Access Compliance Report Public Rights-of-Way (Curb Ramps)

Main Street: VANDERLIP_AVE Cross Street: GERSHON_PL Location: NW

ADA ID: RPAT211006090147 Ramp Type: Blended Transition 2 Initial Pass/Fail: Fail Overall Compliance: No Severity Score: 32

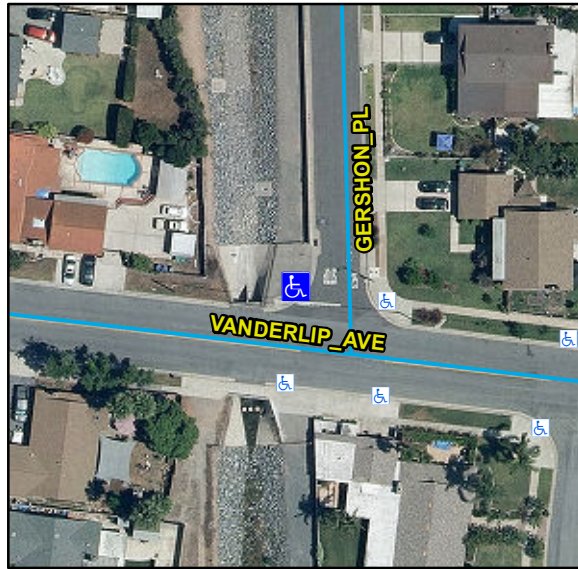
Compliance	Description	Data	Compliance	Description	Data
N/A	Ramp Length (in)	60	N/A	Flare Slope LT (%)	N/A
Yes	Ramp Width (in)	200	N/A	Flare Traversable LT	N/A
No	Ramp Run Slope (%)	14.9	N/A	Flare Slope RT (%)	N/A
No	Ramp Cross Slope (%)	3	N/A	Flare Traversable RT	N/A
N/A	Landing Present	N/A	N/A	DWS Provided	N/A
N/A	Landing Length (in)	N/A	N/A	DWS Contrast	N/A
N/A	Landing Width (in)	N/A	N/A	DWS Length (in)	N/A
N/A	Landing Run Slope (%)	N/A	N/A	DWS Full Width	N/A
N/A	Landing Cross Slope (%)	N/A		DWS Offset Type	N/A
N/A	Landing Movement Obstructed?	N/A	N/A	DWS Offset Left (in)	N/A
	Landing Movement Type	N/A	N/A	DWS Offset Right (in)	N/A
N/A	Landing Shared	N/A			
N/A	Clear Space	Yes			
N/A	Clear Space To Crosswalk (in)	N/A			
N/A	Marked Crosswalk 1	No	N/A	Marked Crosswalk 2	No
	Crossing 1 Direction	S		Crossing 2 Direction	E
	Marked Crosswalk 1 Width (in)	N/A		Marked Crosswalk 2 Width (in)	N/A
N/A	Ramp Inside Crosswalk 1	N/A	N/A	Ramp Inside Crosswalk 2	N/A

Crossing 1 Slope (%)	4.7		Crossing 2 Slope (%)	0.8
	Crossing 1 Cross Slope (%)	0.7		Crossing 2 Cross Slope (%)	2.6
N/A	Gutter Ponding	N/A	No	Curb Slope	5.7
Yes	Gutter Lip Height (in)	0		Road Run Slope (%)	1.3
N/A	Gutter Run Slope (%)	N/A		Road Cross Slope (%)	4.1
N/A	Gutter Cross Slope (%)	N/A			
Yes	Overall Surface Condition	Acceptable			
	Cross Gutter Present?	No		Spandrel Present?	No
	Replace Cross Gutter?	N/A		Replace Spandrel?	N/A

Remove & Replace Curb Ramp With Two New Directional Ramps or Equivalent.

R304.2.2, R304.5.3, STD 1115
